**ADDENDUM NO. 4**

**DATE:** June 19, 2020  
**FROM:** City of Grand Junction Purchasing Division  
**TO:** All Offerors  
**RE:** Riverfront at Dos Rios Phase II Construction IFB-4799-20-DH

**THE RIVERFRONT AT DOS RIOS  
OVERLOT GRADING - 1  
June 19, 2020**

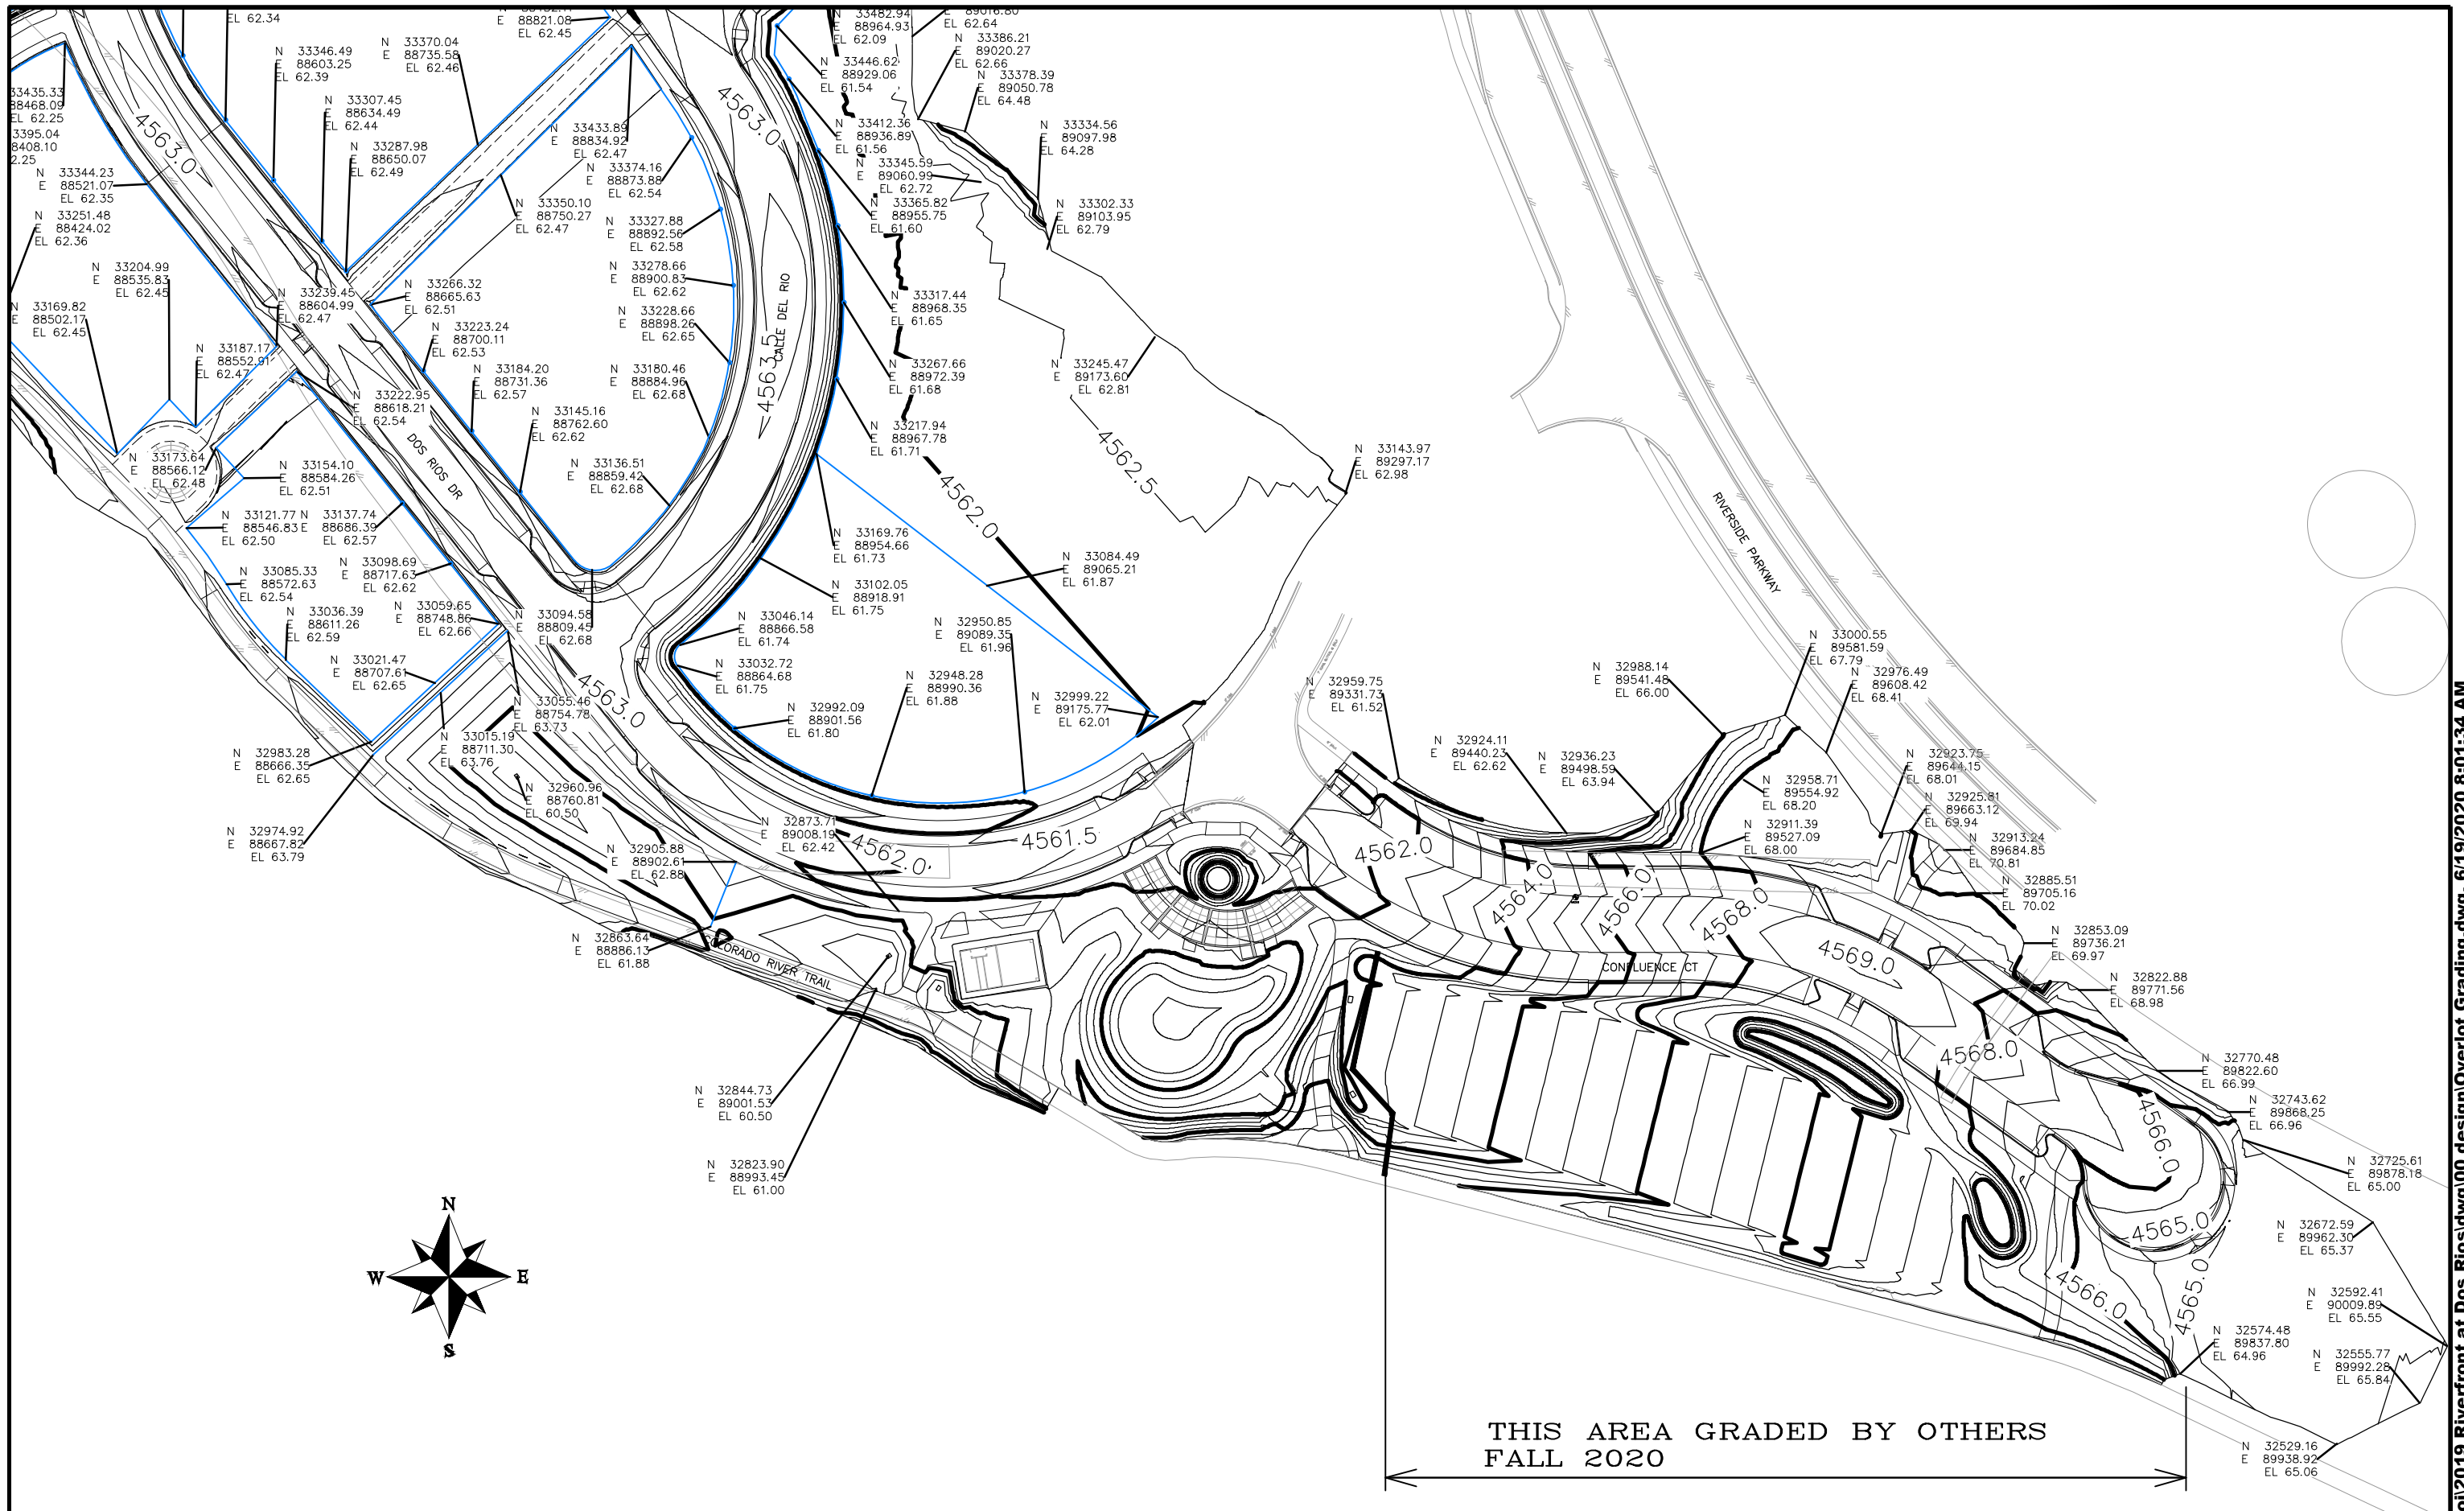
22. Q. Is it possible to provide the site existing grades to correspond with plan sheets 246 & 247 overlot grading plans ?

A. *Please see the Stormwater Management Plan sheets (overall sheets 263-266).*
